PCN – Product Change Notification

| Document No | PCN-A-080222 | Revision | 1.0 | | |

ECN Topic: New I570 SBC are integrated into Winmate's T series Panel PCs

After New T series Panel PC Back Side I/Os:

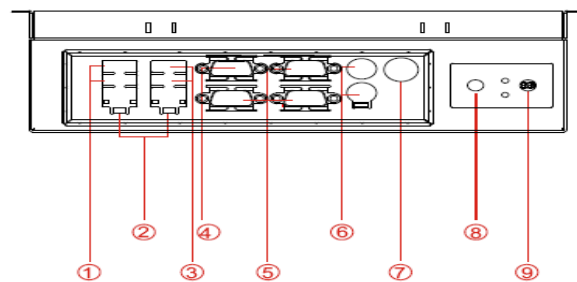
We will use a new I570 Single Board Computer for T series Panel PC. The housing will be the same to original T series Panel PC, but new T series Panel PC Back Side I/Os will be changed. Please refer to the attachment for the detail information.

Original T series Panel PC Back Side I/Os:

| 1. RS-232 Conn. | 6. DVI-I Conn. |
| 2. USB | 7. PS/2 |
| 3. RJ-45 | 8. DC-IN Lockable Power Jack |
| 4. USB | 9. Power On Button |
| 5. Parallel Conn. | 10. Power Reset Button |

| 1. USB | 6. PS/2 |
| 2. RJ-45 | 7. DC-IN Power Jack |
| 3. USB | 8. Power On Button |
| 4. VGA Out | 9. Power Reset Button |
| 5. RS-232 Conn. | |
